# Corrigenda

Installation Guide contain incorrect descriptions. Refer to the following table and confirm the descriptions that are corrected.

WV-X1571LN / WV-X1551LN / WV-X2571LN / WV-X2551LN / WV-S1572L / WV-S1552L / WV-S2572L / WV-S2552L / WV-X4573L / WV-S4551L / WV-X4573LM / WV-S4551LM

## Processing the installation surface (process according to the installation type)

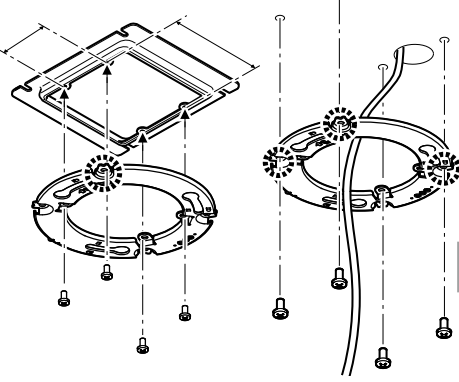
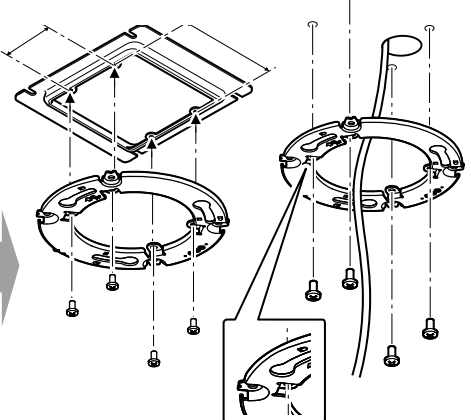
Incorrect	Correct
